CITY OF KIRKLAND
Planning and Building Department
123 Fifth Avenue, Kirkland, WA 98033
425.587.3600 ~ www.kirklandwa.gov

MEMORANDUM

To: Design Review Board
From: Tony Leavitt, Senior Planner
Date: January 31, 2022
File No.: DRV21-00535
Subject: **KIRKLAND URBAN EAST BUILDING
DESIGN RESPONSE CONFERENCE**

Massing Option 3

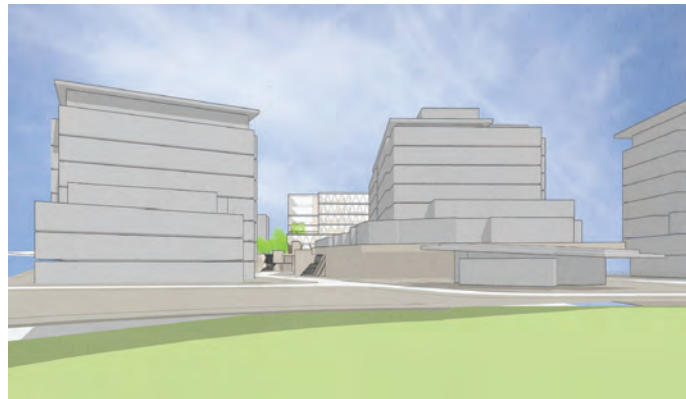
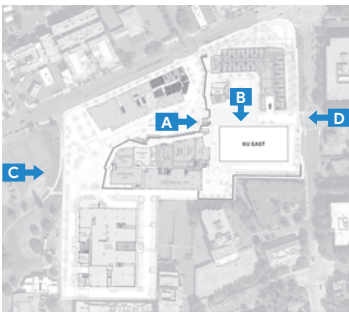
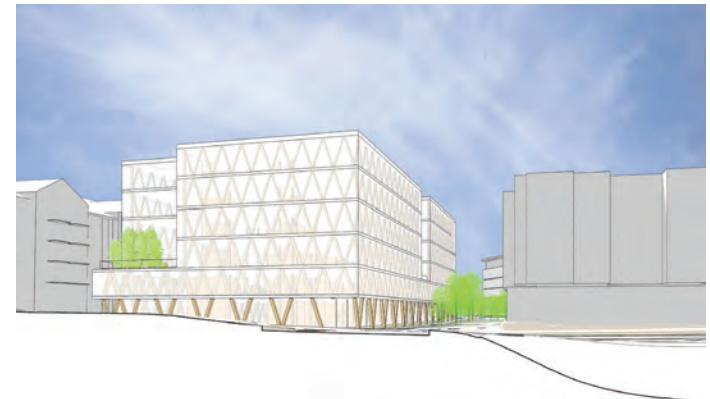
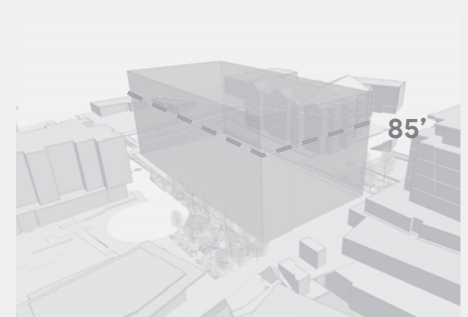
The DRB expressed a preference for [Massing Option 3](#) (the applicant's preferred plan).

The DRB members also requested to see [detailed landscape plans to better understand the relationship between the building massing and the landscape](#), including the following drawings / visualizations:

- Detailed plans for any pedestrian sidewalks or walkways.
[Pg. 21](#)
- Street section drawings showing adjacent street/ access roads and buildings.
[Pg. 31](#) & [Pg. 39](#)
- Detailed plans for the fire lane and landscaping along the south property line.
[Pg. 38](#)
- Detailed plans for the area near the daycare use.
[Pg. 35](#)
- Views of the South side of the building to show the relationship to adjacent buildings.
[Pg. 36](#)
- Facade Development to show how the building relates to the campus as a whole.
[Pg. 568](#)
- Rooftop Visualization
[Pg. 96](#)
